Radar Speed Sign LED Display (YJP7681-188-***) V5.1.2

Release Note

Firmware EEP_TCS001_E_YJP_chip_EN_STD_V5.1.2 build260727

2.2 Support speed unit toggle display, selectable between km/h and mph

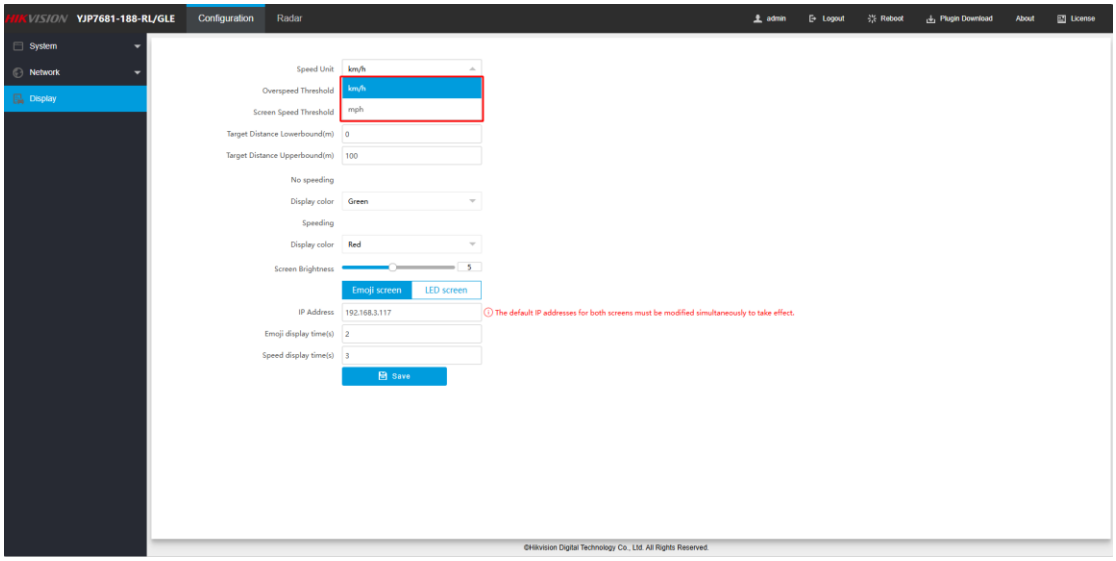
The default unit is kilometers. Applicable models: YJP7681-188-RL/GLE , YJP7681-188-R

2.3 Support ISAPI listening for integration with third-party platforms

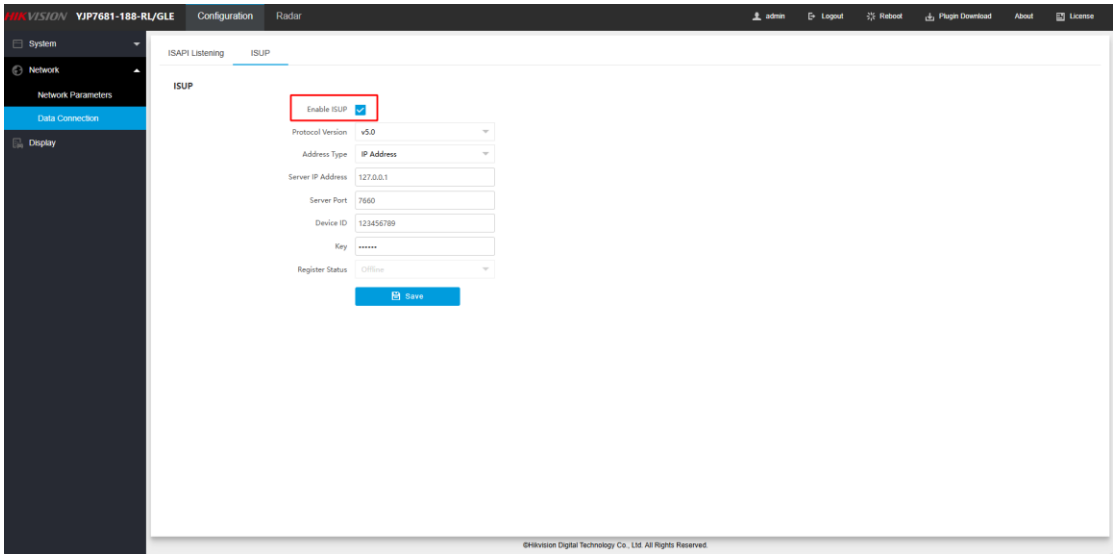
Upload speed and traffic flow information.

2.4 Support ISUP protocol for integration with HCP platform (V3.1.1)

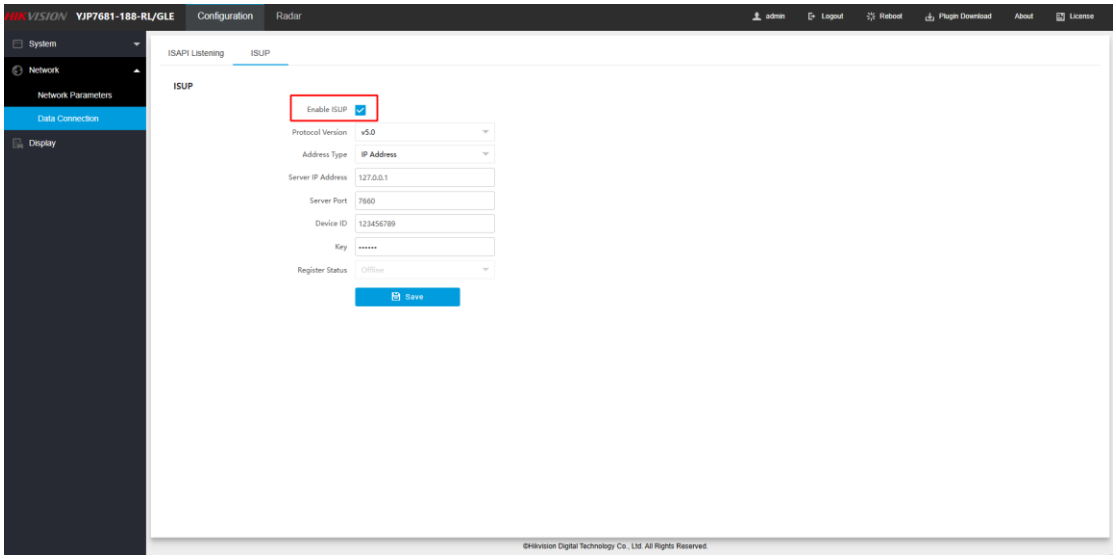
Upload solar energy charge information.

2.5 Support Google Mail sending

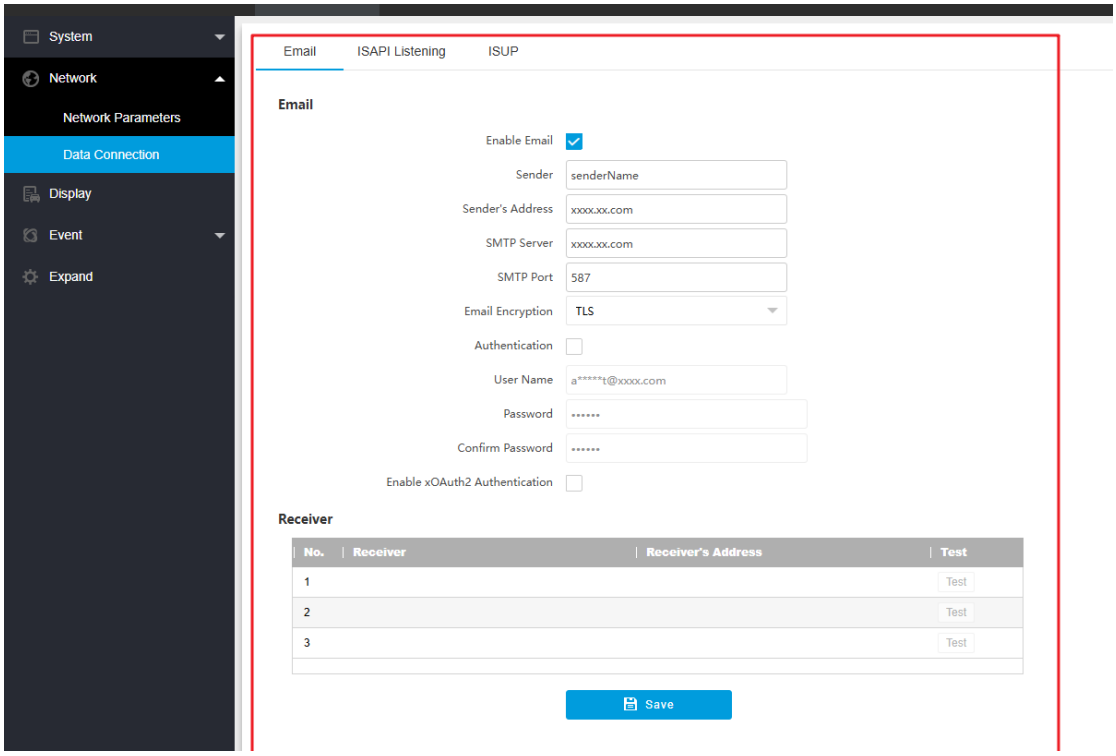
Applicable model: YJP7681-188-RL/GLE

2.6 Support IP modification for NR model LED and 188 screen

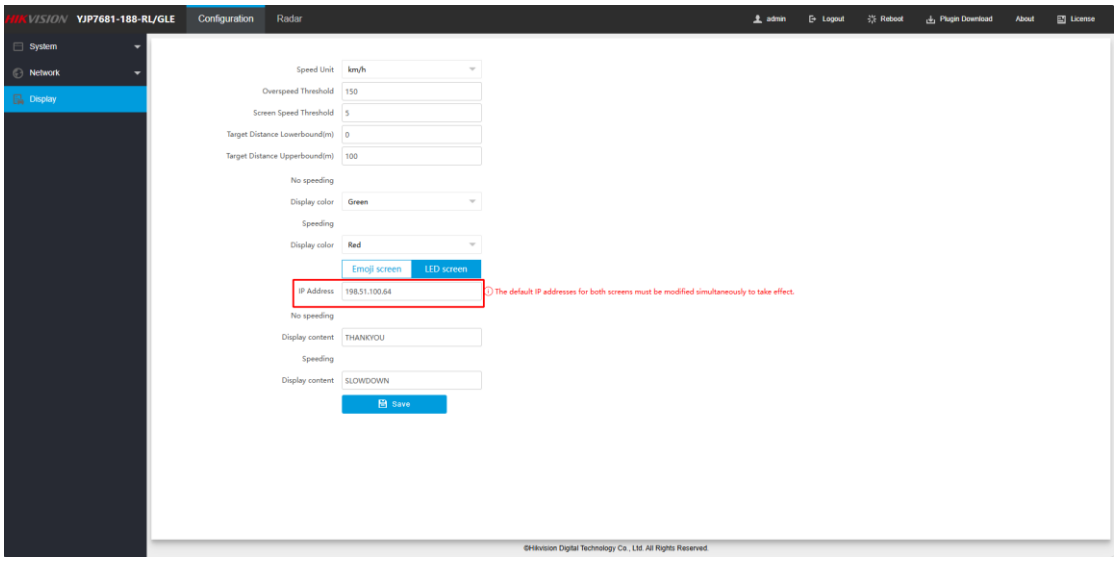
Applicable model: YJP7681-188-NR

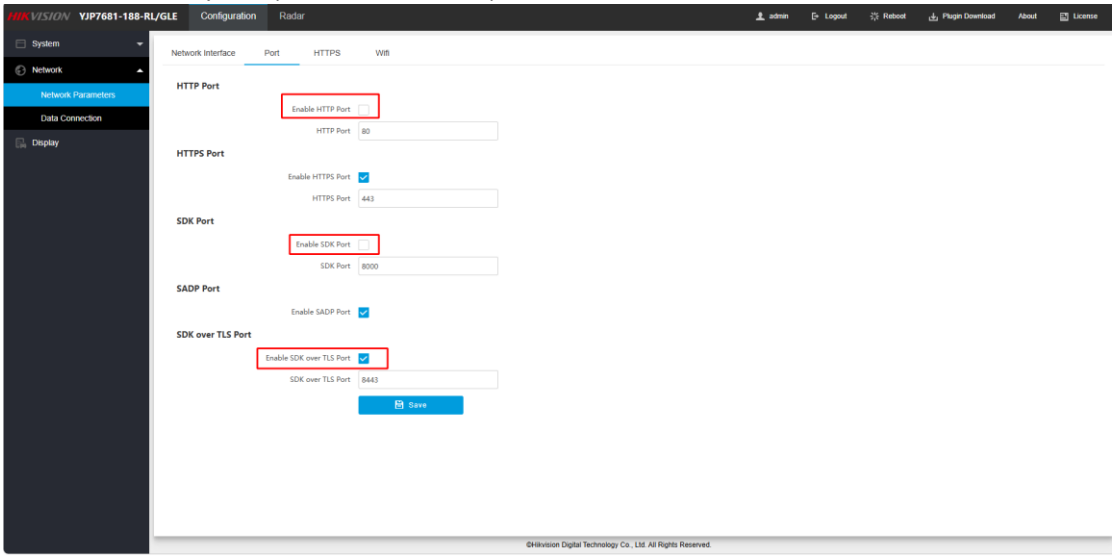
1. Default HTTP port is disabled and HTTPS is enabled. Applicable models: YJP7681-188-RL/GLE , YJP7681-188-R , YJP7681-188-NR

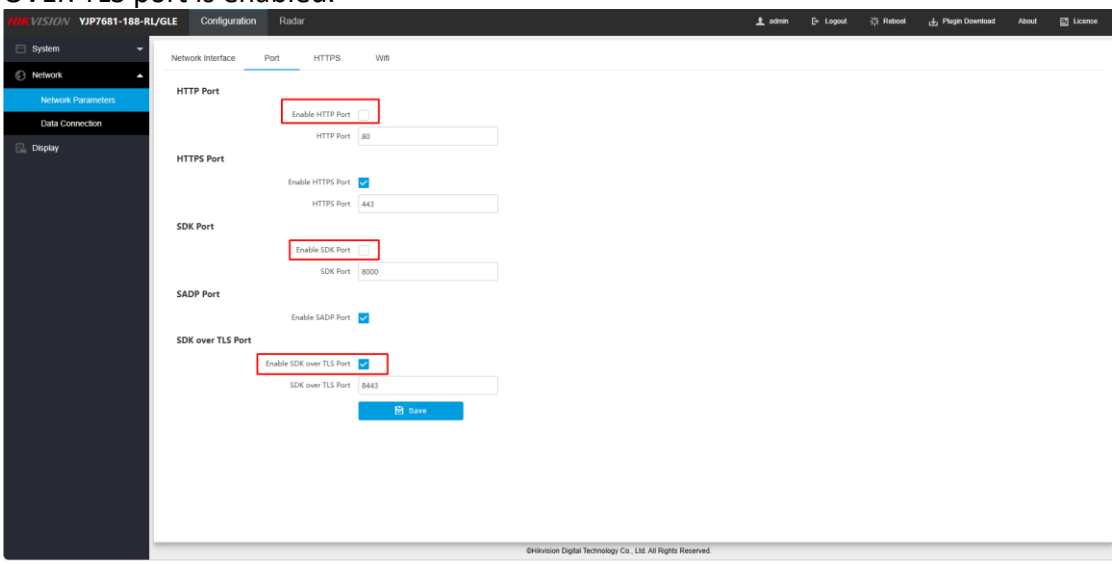
2. Default SDK port is disabled; an SDK port enable option is added, and the SDK OVER TLS port is enabled.

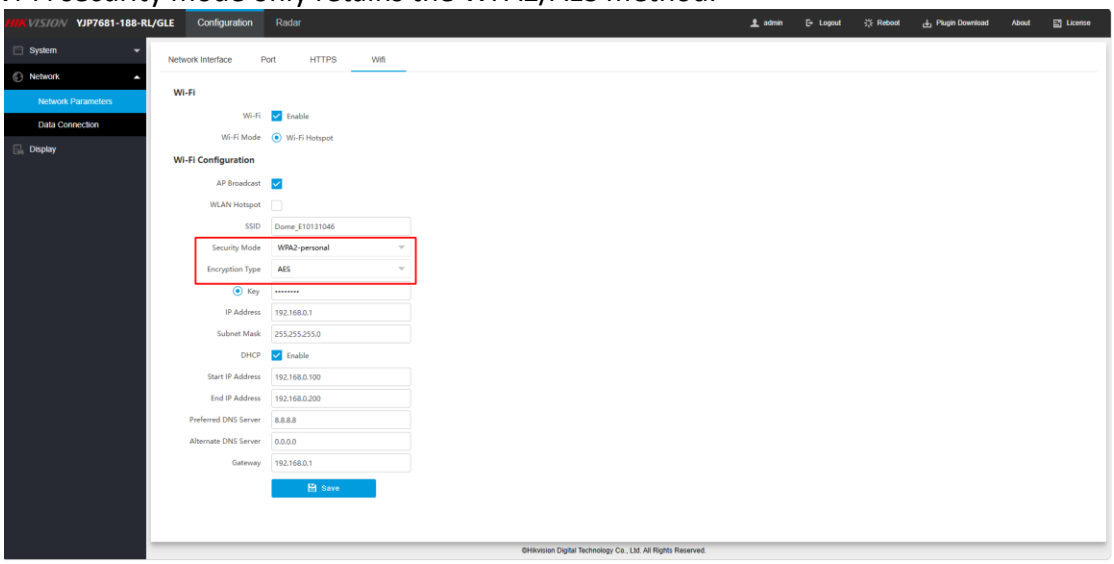
3. Wi-Fi security mode only retains the WPA2/AES method.

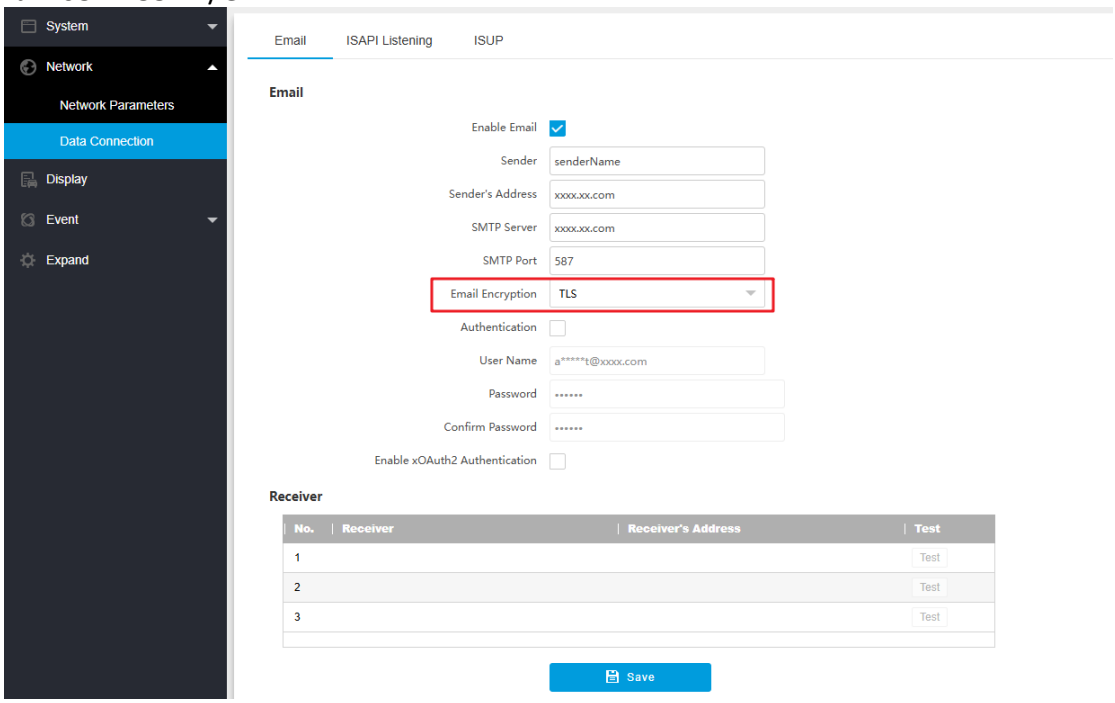
4. The default email encryption method is set to TLS. Applicable model: YJP7681-188-RL/GLE.

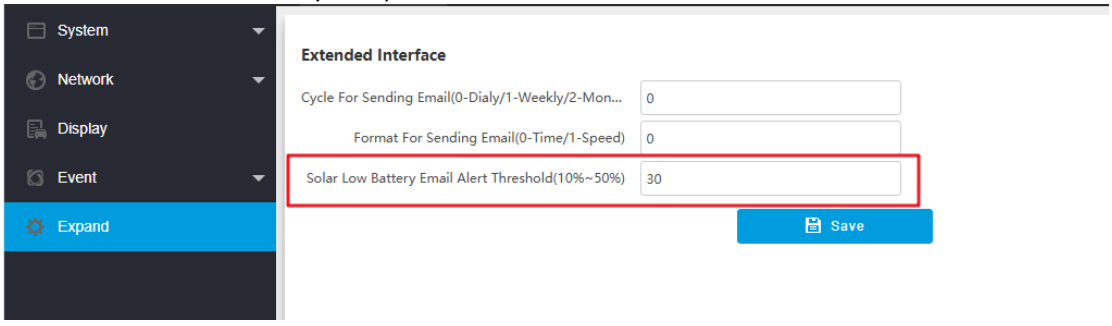
5. Low battery alarm range 10-50%, default value changed to 30%. Applicable models: YJP7681-188-RL/GLE , YJP7681-188-R.
